DART AEROSPACE LTD	Work Order:	107337
Description: Crosstube Assembly	Part Number:	D407-667-145
Inspection Dwg: D407-667-145 Rev: C		Page 1 of 2

DESIGN	9	DART AEROSPACE LTD	
DRAWN	RF	HAWKESBURY, ONTARIO, CANADA	
CHECKED	CP	DRAWING NO.	REV. C
MFG. APPR.	CP	D407-667-145	SHEET 4 OF 4
APPROVED	CP	TITLE	SCALE
DE APPR.	CP	CROSSTUBE ASS'Y (407 HIGH FWD)	NTS
DATE	08.11.06	<small>COPYRIGHT © 2002 BY DART AEROSPACE LTD THIS DOCUMENT IS PRIVATE AND CONFIDENTIAL AND IS SUPPLIED ON THE EXPRESS CONDITION THAT IT IS NOT TO BE USED FOR ANY PURPOSES OR COPIED OR COMMUNICATED TO ANY OTHER PERSON WITHOUT WRITTEN PERMISSION FROM DART AEROSPACE LTD.</small>

DRAWING NO. D407-667-145	TITLE CROSSTUBE ASS'Y (407 HIGH FWD)	REV. C	DART AEROSPACE LTD ENGINEERING ORDER		D.E.O. NO. D407-667-145-C-1	SHEET NO. SHEET 1 OF 1	SCALE NTS
DRAWN JP	CHECKED ASS	MFG. APPR. KBS	APPROVED WD		DE APPR. H		
DATE 11.07.15	DATE 11.07.22	DATE 11.07.22	DATE 11/07/22		DATE 11.07.21

DRAWING NO. D407-667-145	TITLE CROSSTUBE ASS'Y (407 HIGH FWD)	REV. C	DART AEROSPACE LTD ENGINEERING ORDER	D.E.O. NO. D407-667-145-C-2	SHEET NO. SHEET 1 OF 1	SCALE NTS
DRAWN AJS	CHECKED	MFG. APPR. <i>E</i>	APPROVED <i>AD</i>	DE APPR. <i>AD</i>		
DATE 1

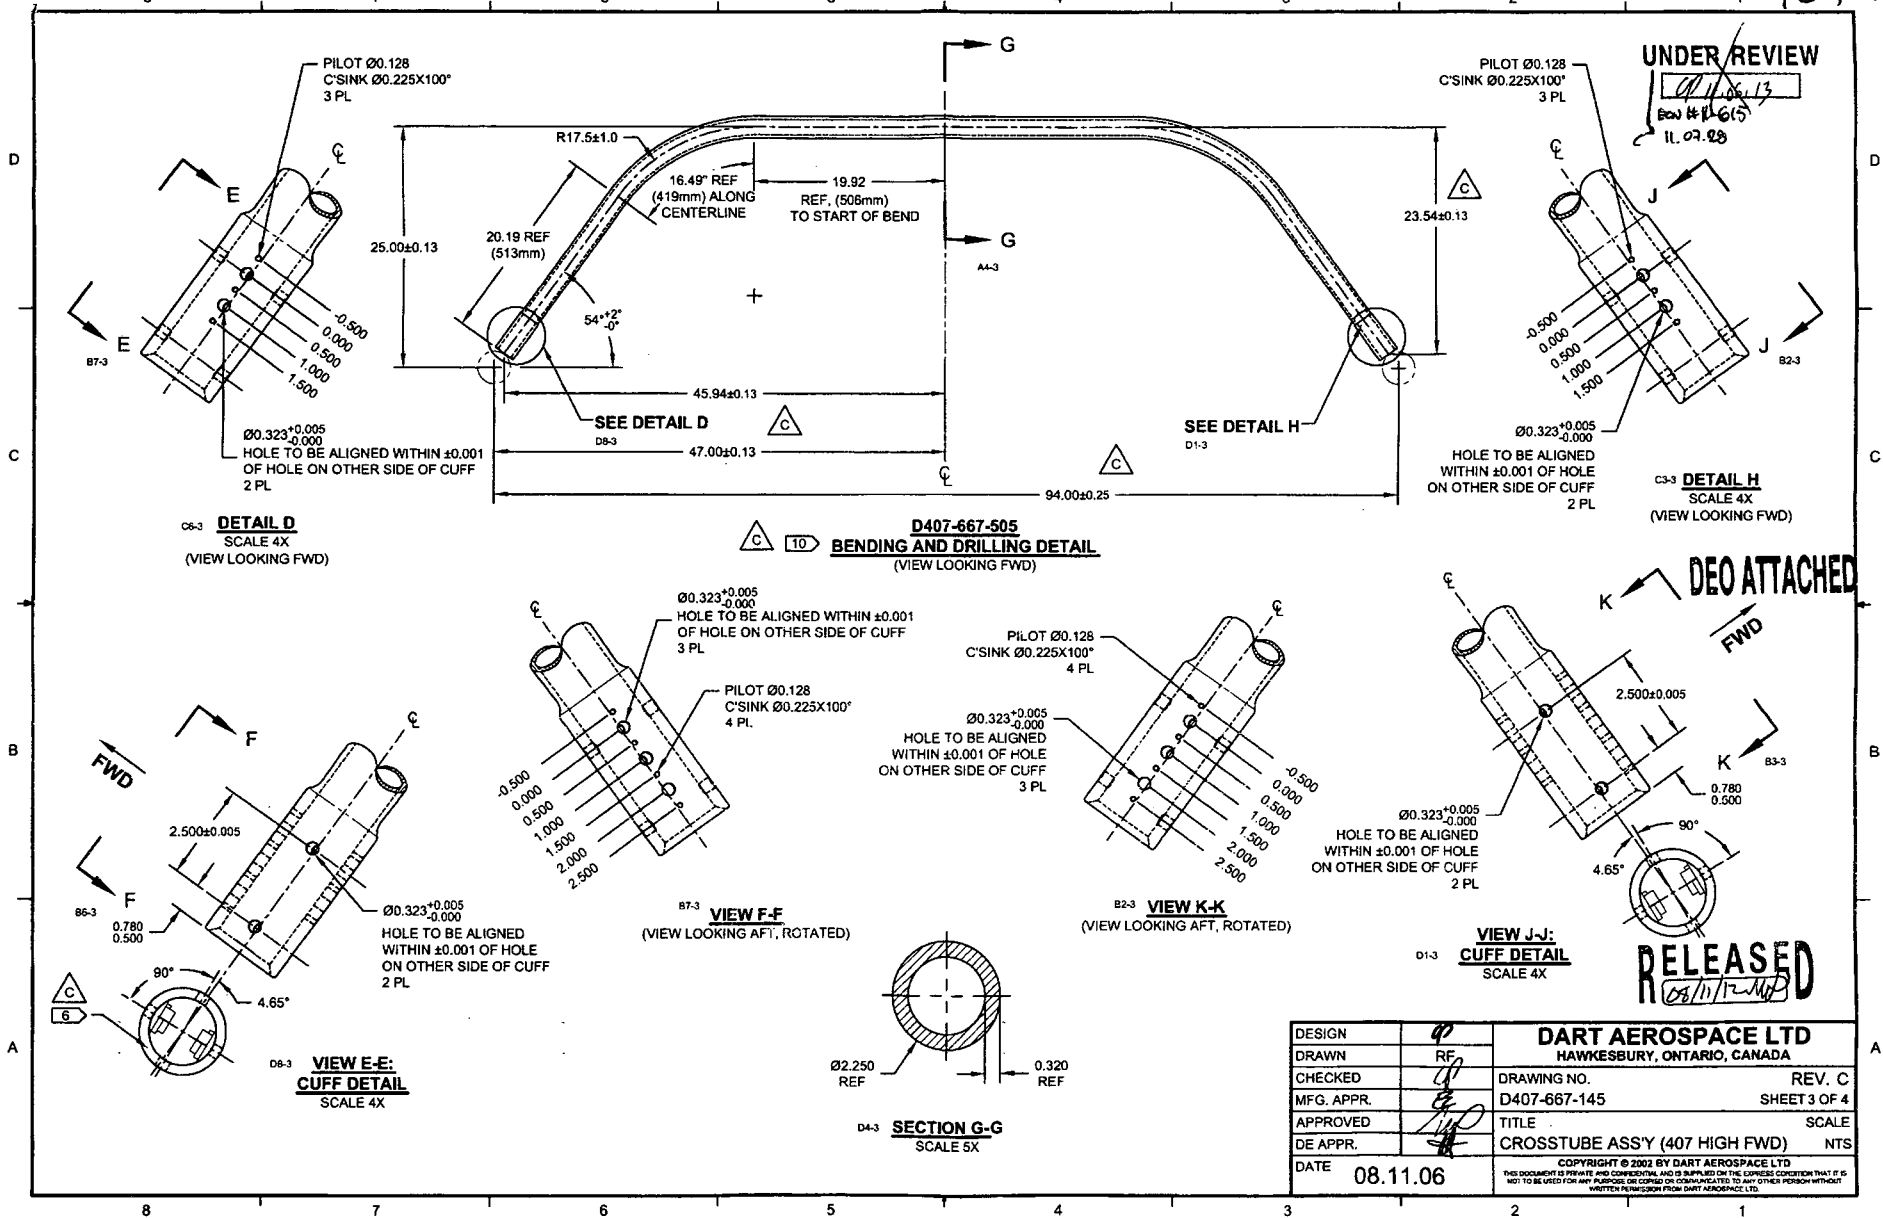
PURPOSE:

REPLACE MAGNOBOND WITH PROSEAL.

IS:

Item	Qty -145	Part Number	Description
9	A/R	PROSEAL 890 B-2	SEALANT, AMS-S-8802 CLASS B-2

WAS:

9	A/R	MAGNOBOND 6398	ROCKWELL SPECIFICATION RBO-120-023 ADHESIVE (TEXTRON/BELL SPEC. 299-947-100, TYPE II, CLASS 2 ADHESIVE)
---	-----	----------------	---

NOTE 12 & 15, SHEET 1 IS AMENDED AS FOLLOWS:

IS:

- 12) TO INSTALL D2891-1 SUPPORT: ABRABE MATING SURFACE OF SUPPORT AND CROSSTUBE WITH 180-GRIT SANDPAPER AND REMOVE RESIDUE WITH MEK (OR EQUIVALENT). APPLY A 0.04" TO 0.07" THICK LAYER OF PROSEAL 890 CLASS B-2 (OR AMS-S-8802 CLASS B-2) SEALANT TO MATING SURFACE OF SUPPORT.
- 15) TORQUE CLAMPS 80 TO 100 IN-LB. ENSURE AT LEAST 1.5 THREADS SHOWING IN SAFETY AND THAT NUT HAS NOT BOTTOMED-OUT AFTER TORQUING. **PRIOR TO PACKAGING, RE-CHECK TORQUE ON CLAMPS AFTER PROSEAL 890 SEALANT HAS CURED FOR 72 HOURS.**

WAS:

- 12) INSTALL D2891-1 SUPPORT USING 0.03" TO 0.06" THICK LAYER OF MAGNOBOND 6398 PER QSI 015. LET CURE FOR 12 HOURS AFTER INSTALLATION AND PRIOR TO PACKAGING.
- 15) TORQUE CLAMPS 80 TO 100 IN-LB. ENSURE AT LEAST 1.5 THREADS SHOWING IN SAFETY AND THAT NUT HAS NOT BOTTOMED-OUT AFTER TORQUING.

PURPOSE:

ADD ELECTRICAL GROUNDING STRAP

ITEM	QTY -145	PART NUMBER	DESCRIPTION
1	X	D407-667-145	CROSSTUBE ASSEMBLY (407 HIGH FWD)
10	2	AN742D36	CLAMP
11	2	MS9165-05	ANGLE BRACKET
12	2	MS21042L3	NUT (OR MS21042-3)
13	2	MS27039-1-08	SCREW
14	4	NAS1149C0332R	WASHER (OR AN960C10L)

- 16) MASK AREA UNDER CLAMP PRIOR TO PAINTING
- 17) SEAL EDGES WHERE AN742D36 CLAMP MEETS WITH THE CROSSTUBE USING SIKAFLEX-241/-291 OR MIL-S-8802 CLASS B2 OR PROSEAL 890 SEALANT
- 18) PERFORM RESISTANCE CHECK TO ENSURE MAX RESISTANCE IS 10 MILLIOHMS
